# UNITED STATES PATENT AND TRADEMARK OFFICE

10/626,361

Jeremy A. Davis

## Office Action Summary

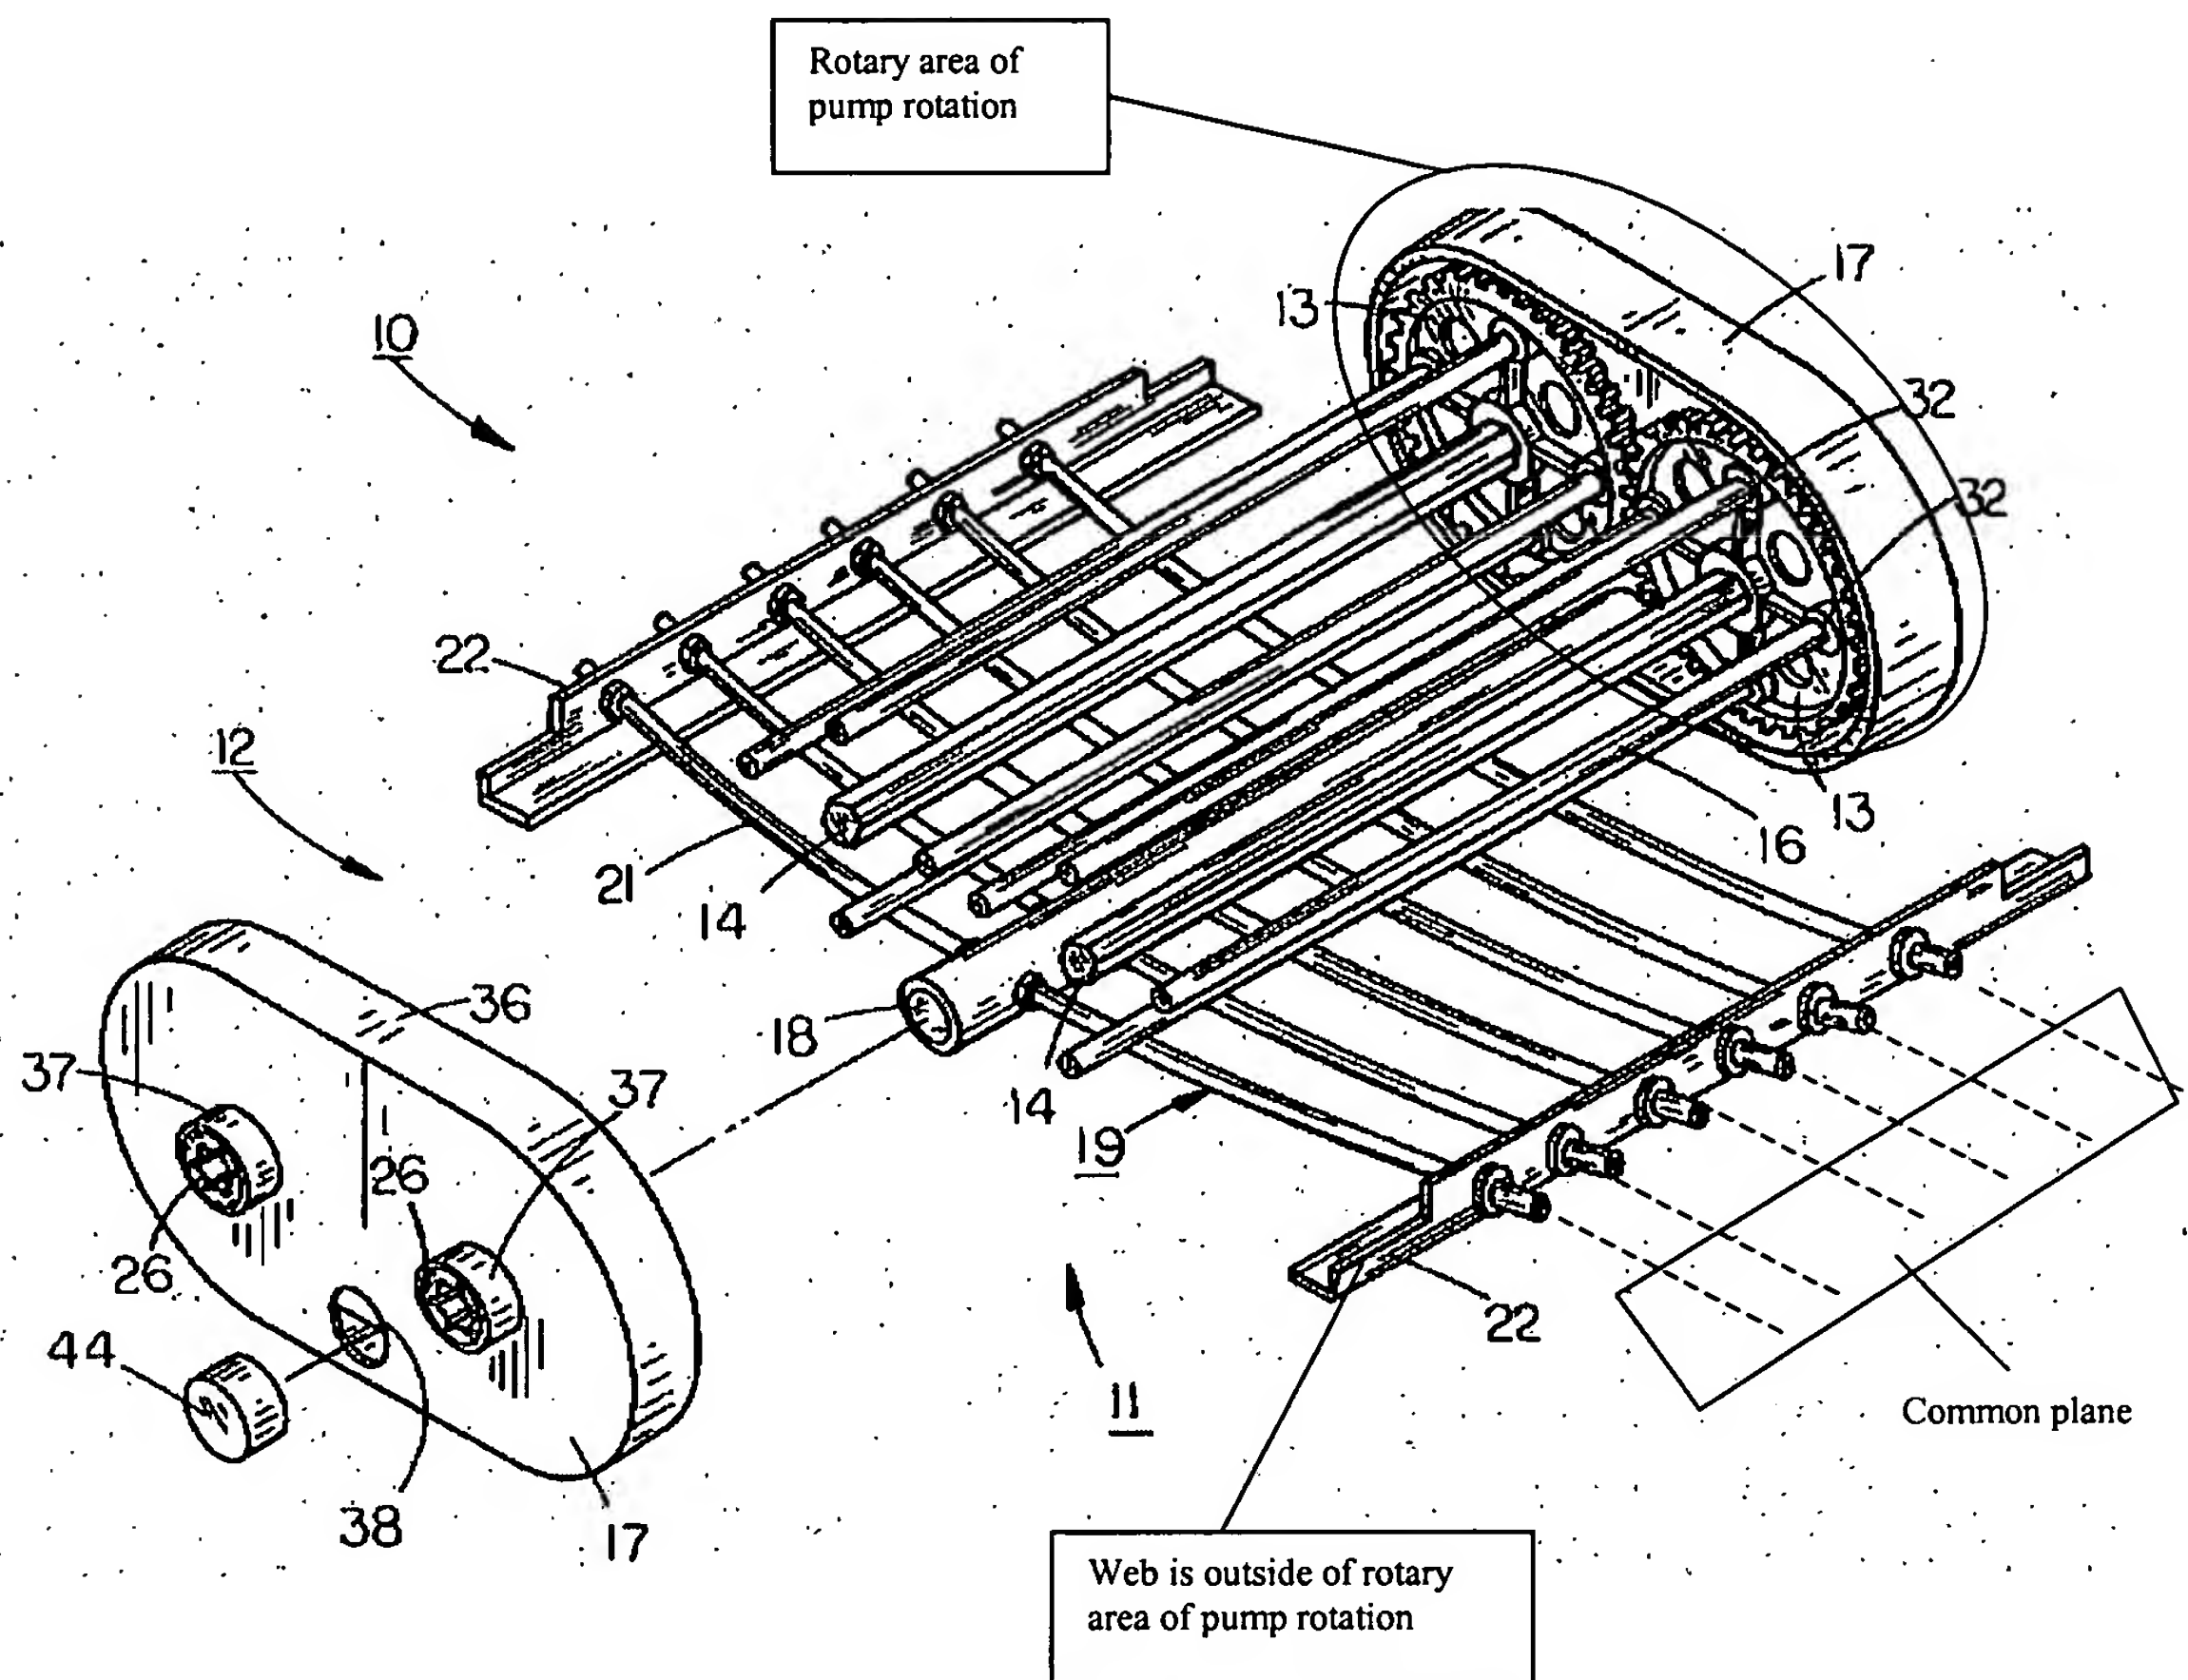
With respect to claim 1, **Schartz** teaches a pump having a rotary portion 16 which compels the movement of a fluid by peristaltic compression of resilient tubing 19 containing the fluid, a tube component comprising a plurality of adjacent resilient tubes; a web 22 interconnecting the adjacent resilient tubes, the resilient tubes has a cross-sectional centerline occurring in a common plane, and the web interconnects the resilient tubes in an area outside of the common plane, the rotary portion of the pump includes a rotary area of pump operation, and the web is outside the rotary area of pump operation. See particularly Figure above.

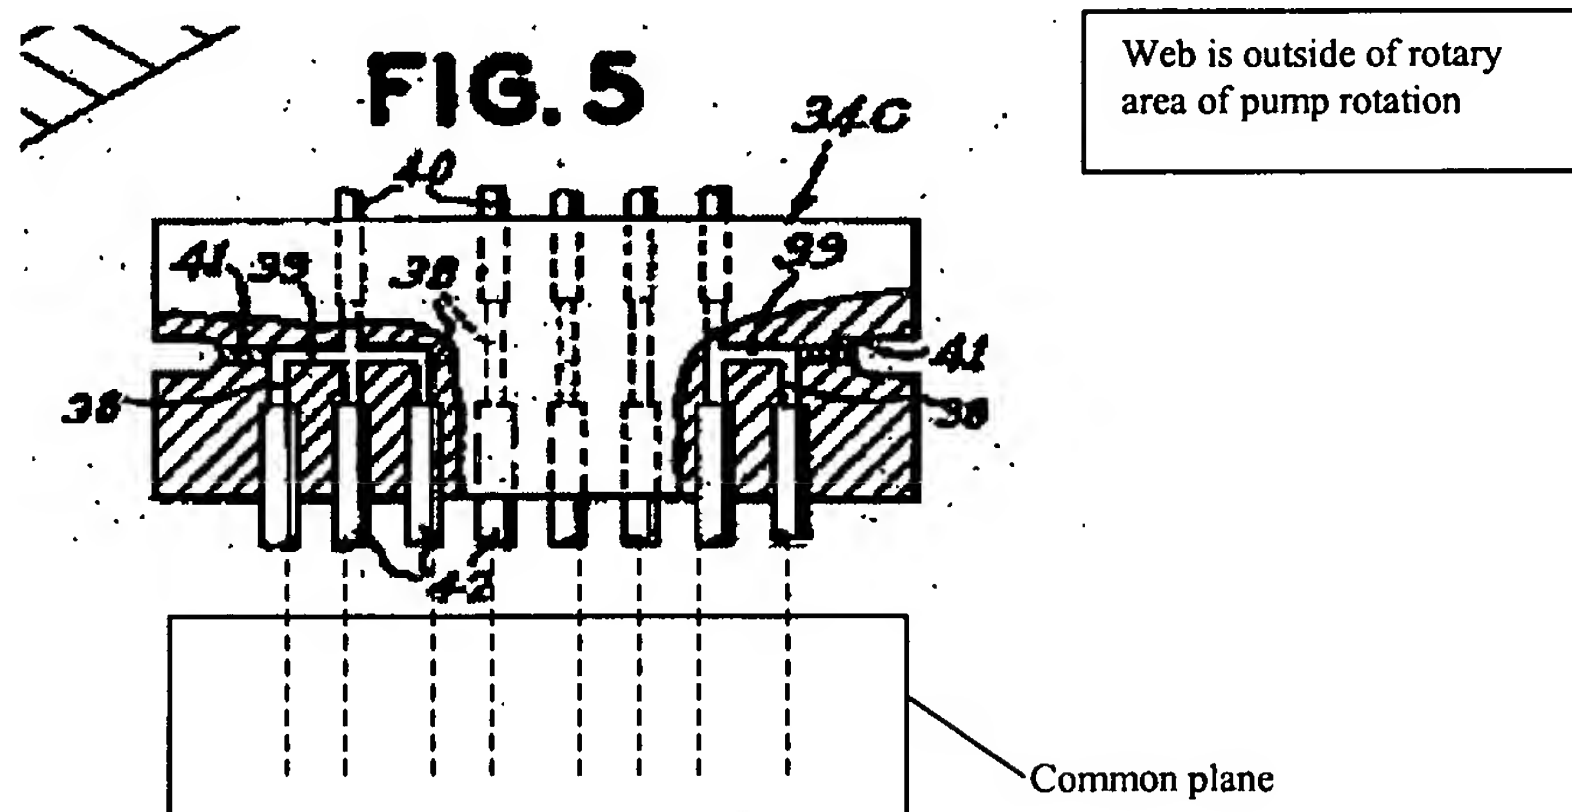
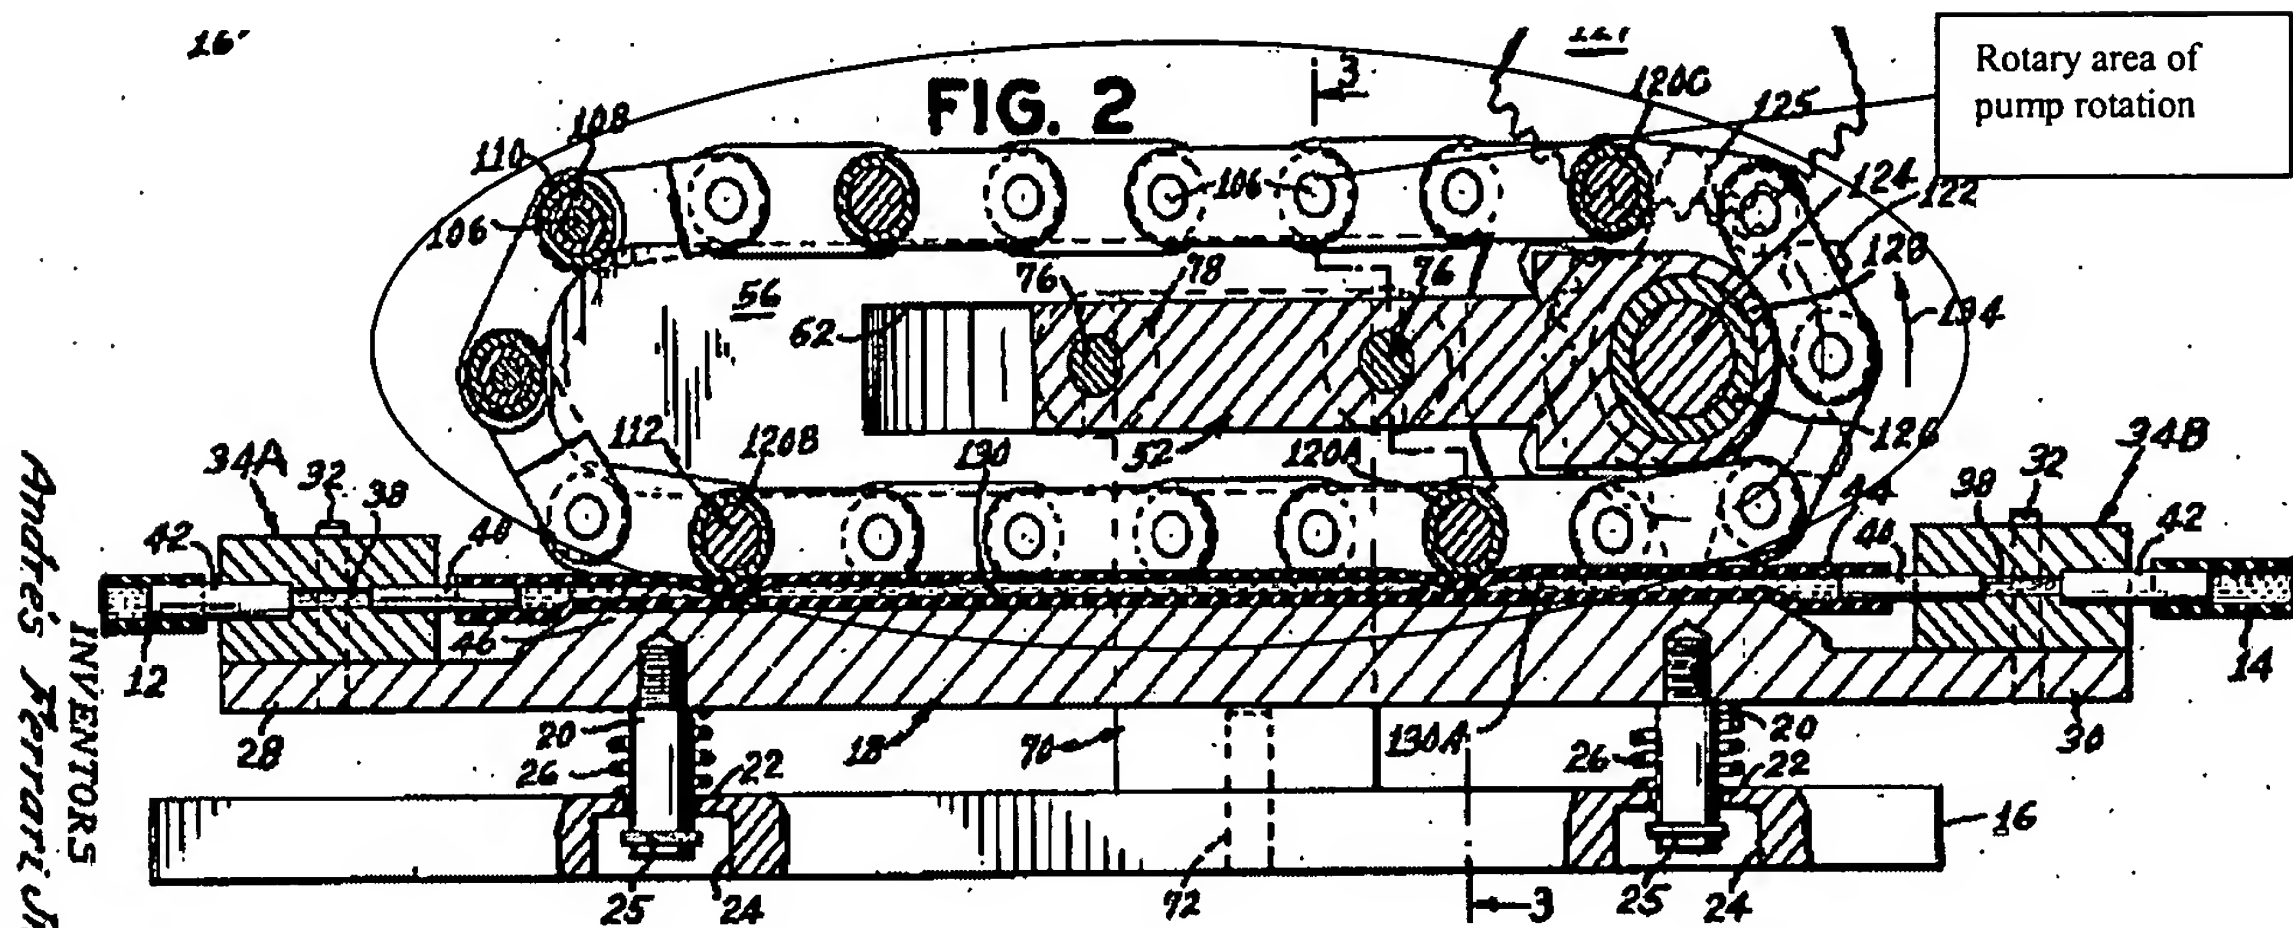
With respect to claim 1, **Ferrari** teaches a pump having a rotary portion 120 which compels the movement of a fluid by peristaltic compression of resilient tubing (44, 40, 42) containing the fluid, a tube component comprising a plurality of adjacent resilient tubes; a web 34C interconnecting the adjacent resilient tubes, the resilient tubes has a cross-sectional centerline occurring in a common plane, and the web interconnects the resilient tubes in an area outside of the common plane, the rotary portion of the pump includes a rotary area of pump operation, and the web is outside the rotary area of pump operation. See particularly **Figures 2, 5** above and column 4 lines 59-71 of Ferrari.

With respect to claim 13, **Ferrari** teaches a method of assembling a pump having a rotary portion 120 which compels the movement of a fluid by peristaltic compression of resilient tubing (40, 42, 44) containing the fluid comprising the following: providing a plurality of adjacent resilient tubes, and interconnecting the adjacent resilient tubes with a web 34C, providing a plurality of adjacent resilient tubes comprises providing each of the resilient tubes with a cross-sectional centerline occurring in a common plane, and interconnecting the adjacent resilient tubes with a web comprises interconnecting the resilient tubes in an area outside of the common plane, the rotary portion of the pump includes a rotary area of pump operation, and interconnecting the adjacent resilient tubes with a web comprises interconnecting the resilient tubes in an area outside the rotary area of pump operation. See particularly **Figures 2, 5** above and column 4 lines 59-71 of Ferrari.
